STATE OF VERMONT AGENCY OF TRANSPORTATION

PROPOSED IMPROVEMENT BRIDGE PROJECT TOWN OF BRATTLEBORO COUNTY OF WINDHAM

ELLIOT ST (TH #446) (URBAN COLLECTOR) BRIDGE NO. 31

SHOP DRAWING REVIEW

WEST RAILING, FACING WEST

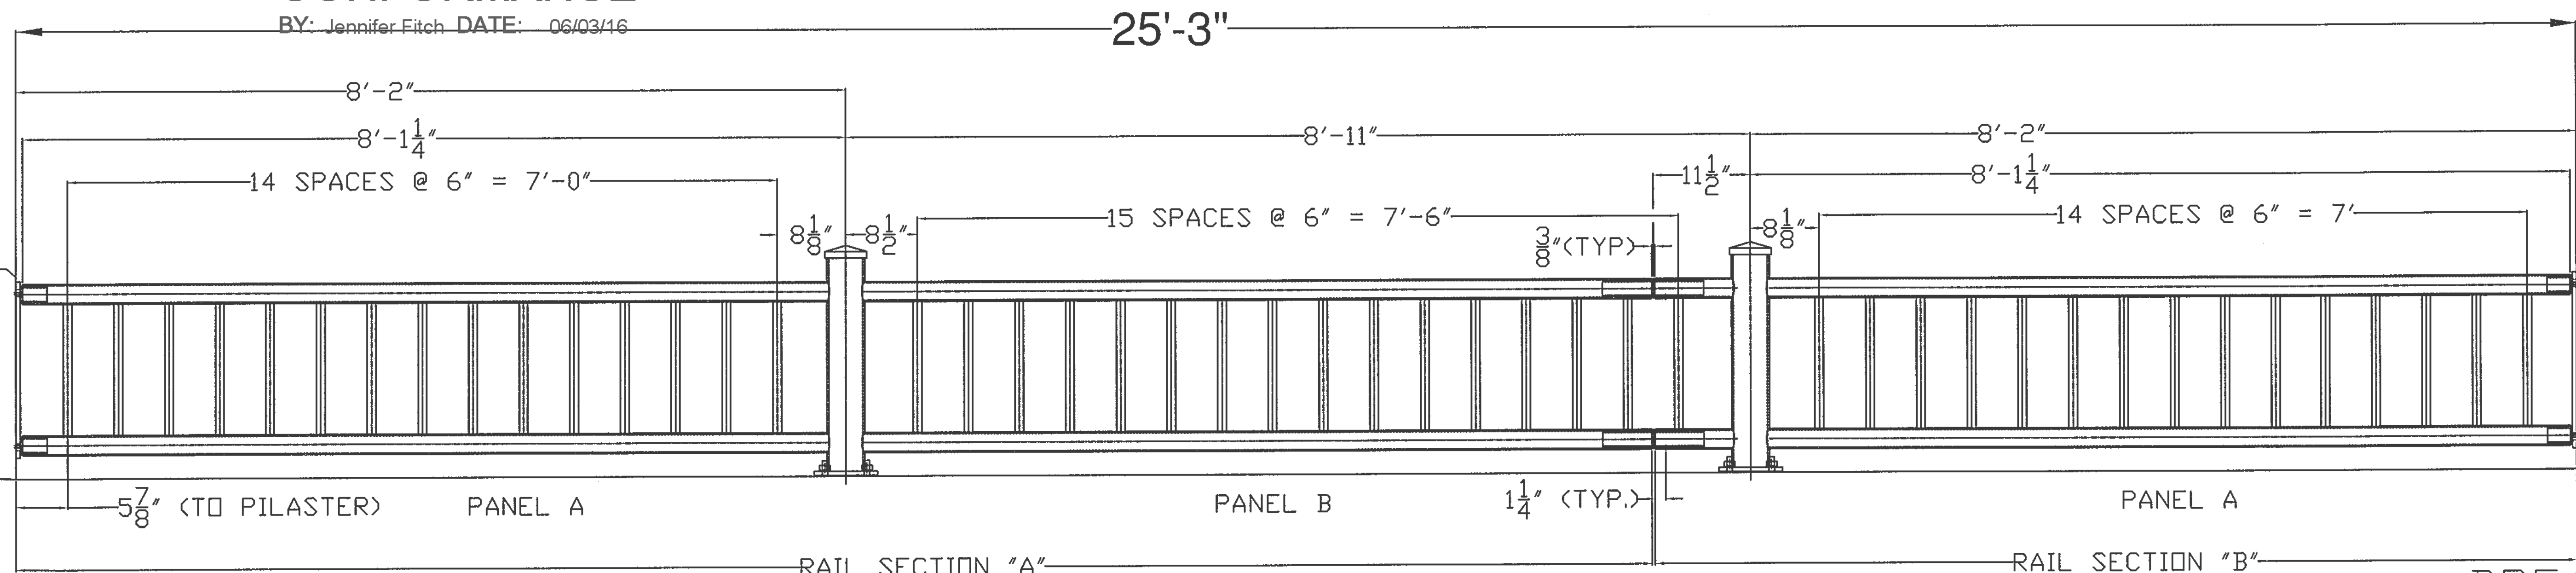
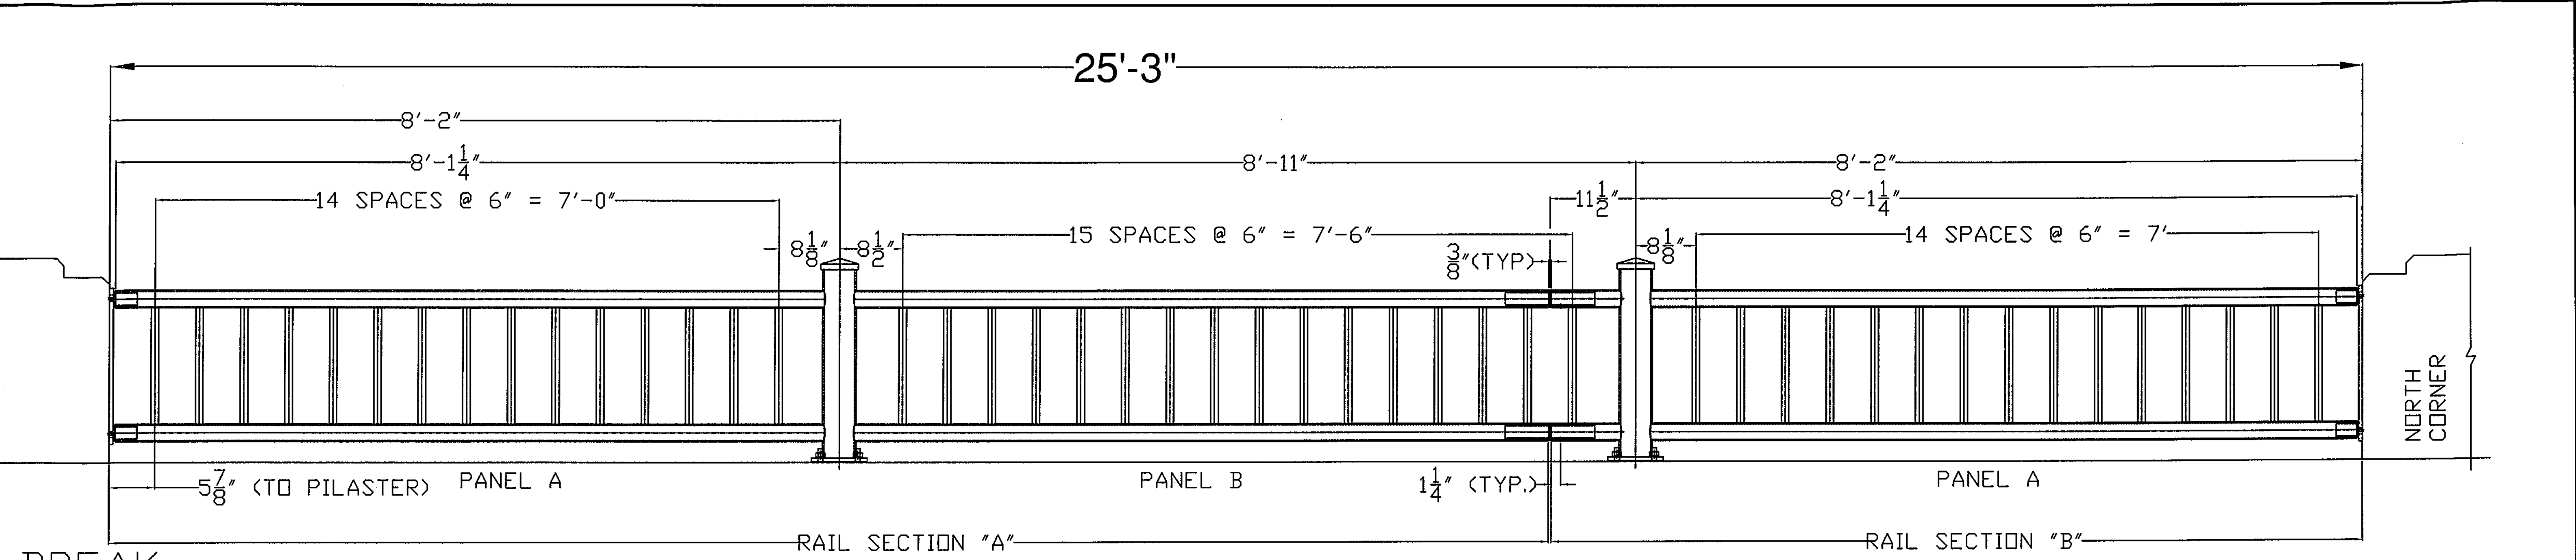
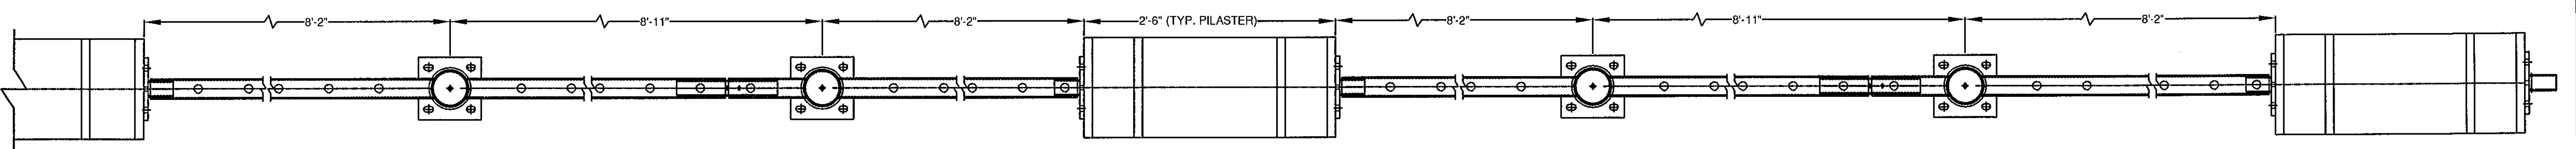
R NO.	DATE	DESCRIPTION	BY	R NO.	DATE	DESCRIPTION	BY
E 1	6/2/16	REVISED PER 5/18/16 DWG REVIEW	E.P.	E 1

DECK REINFORCEMENT PLAN
CONTRACT REF. SHEET 13

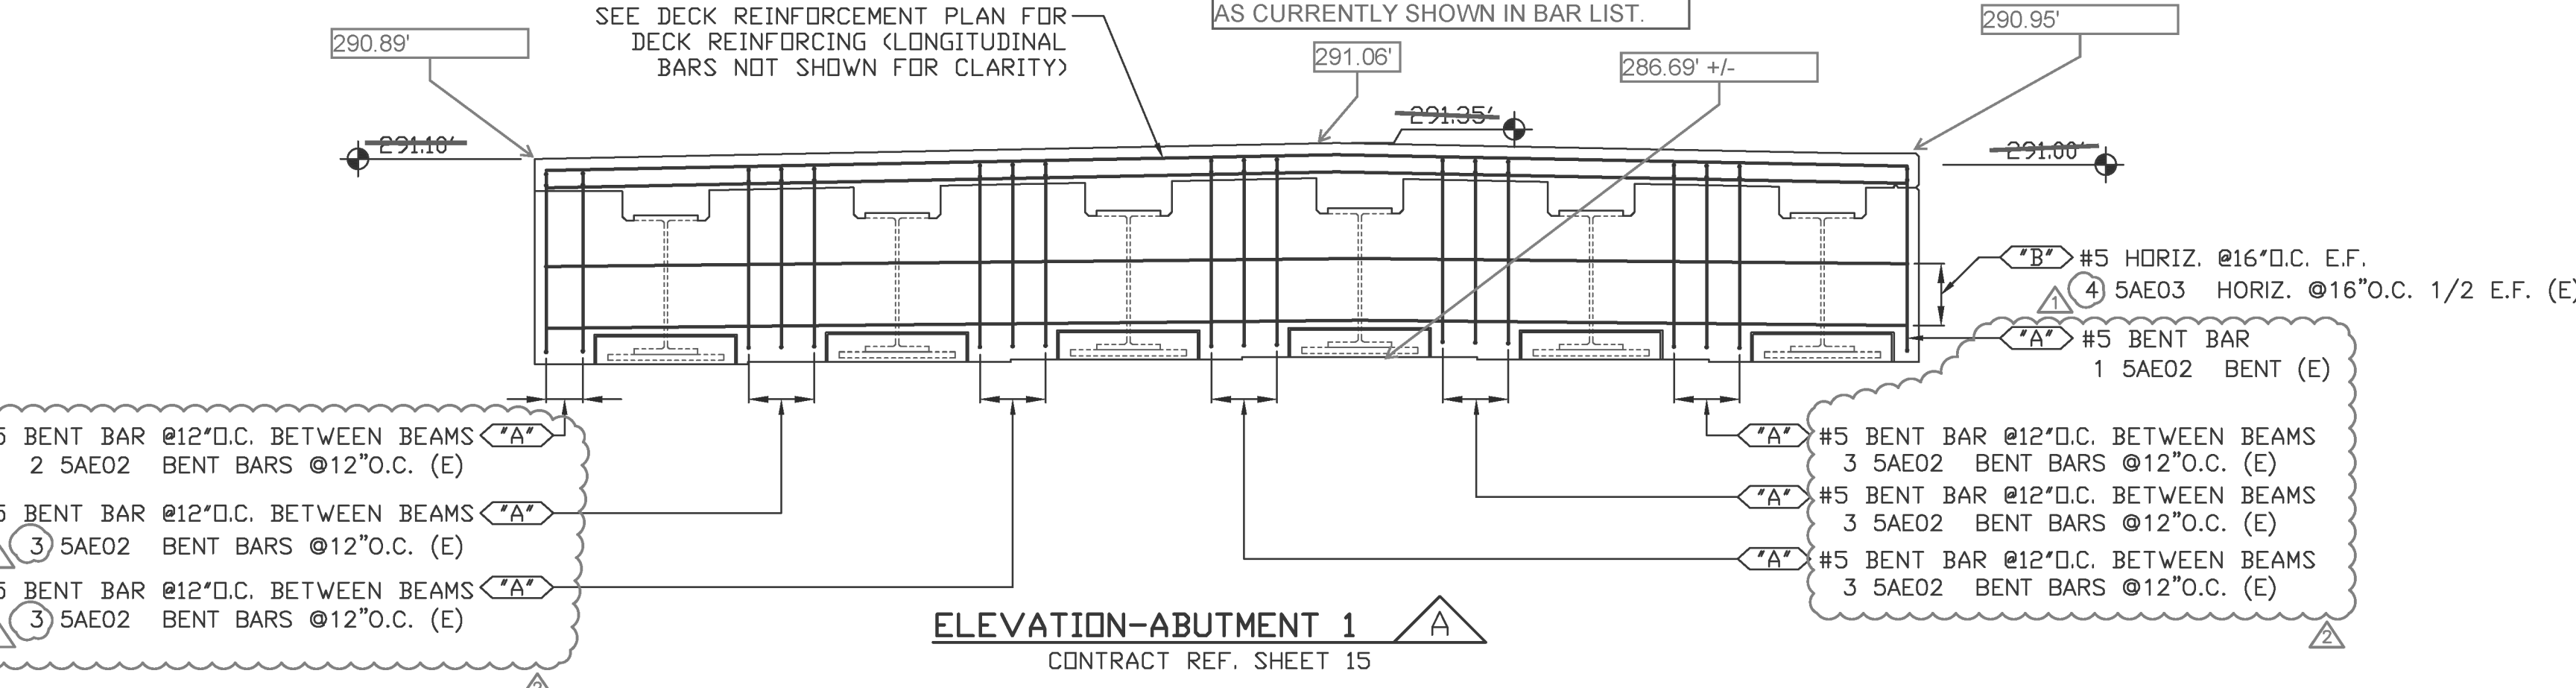
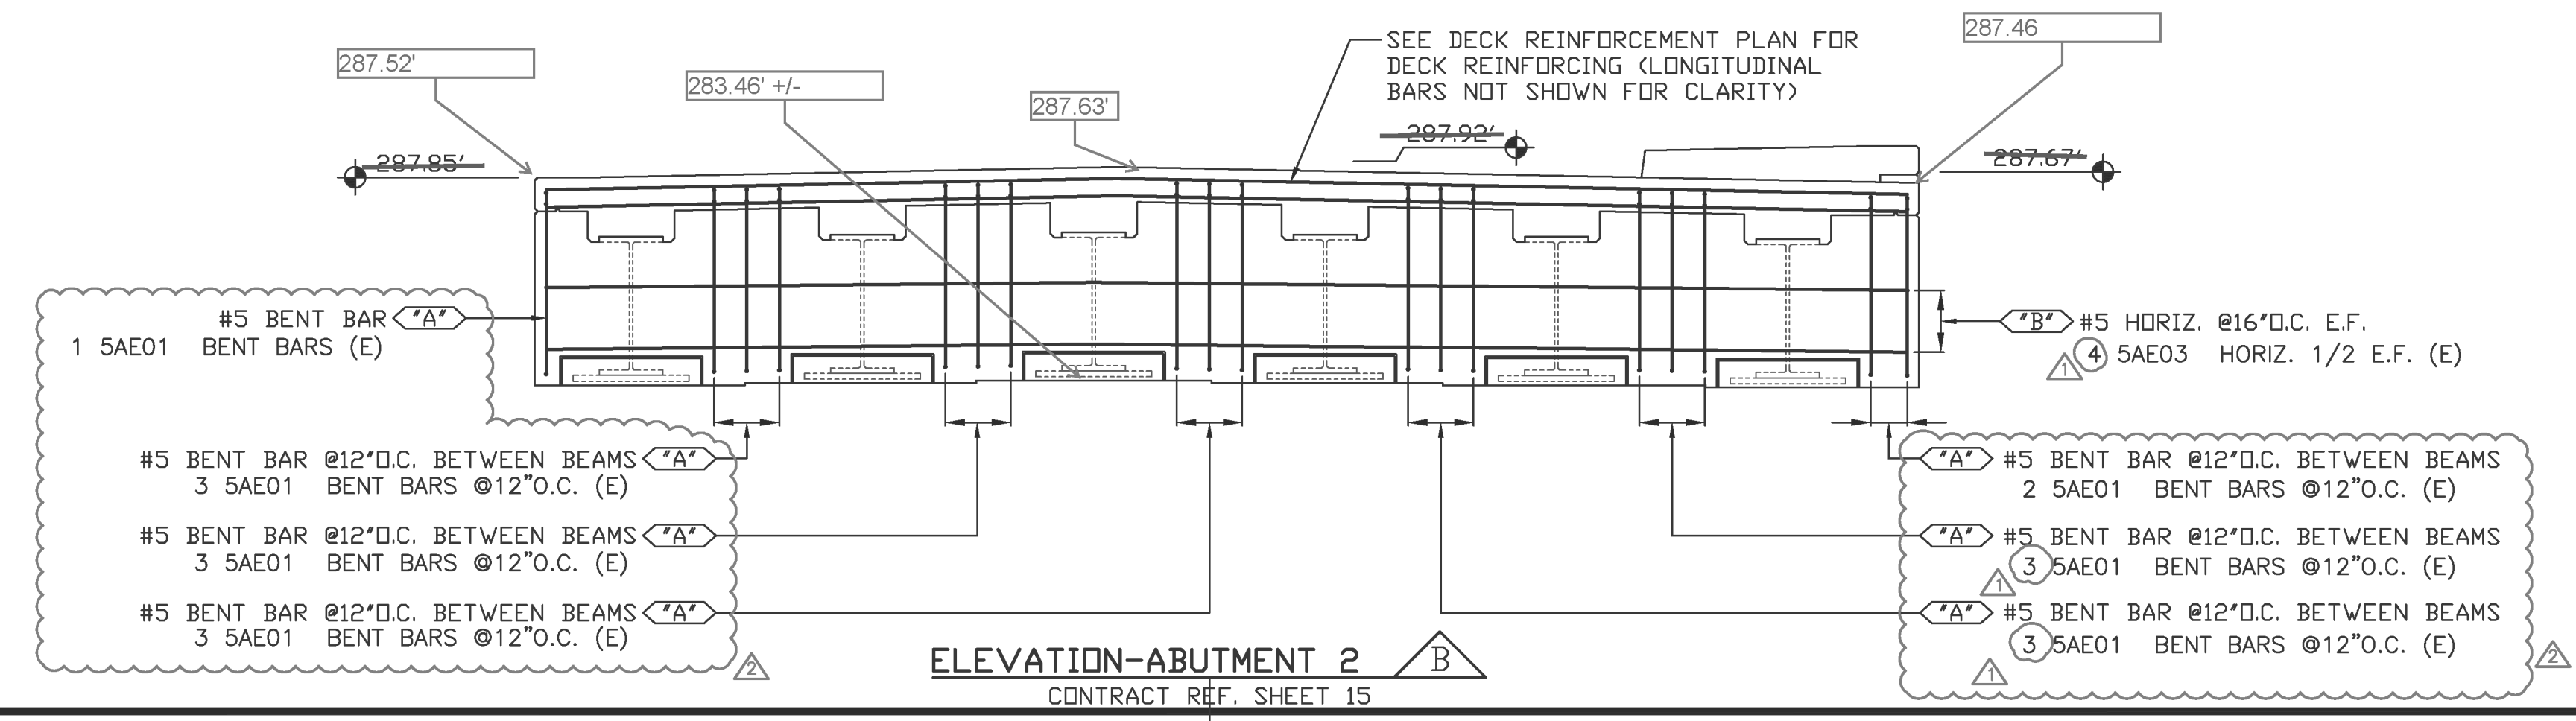
PLEASE NOTE - THE FINISHED GRADE ELEVATIONS HAVE BEEN REVISED ALONG THE LENGTH OF THE BRIDGE. SEE NEW ELEVATIONS BELOW. HOWEVER, IT APPEARS THAT THE CURTAIN WALL BAR LENGTHS ARE OK AS CURRENTLY SHOWN IN BAR LIST.
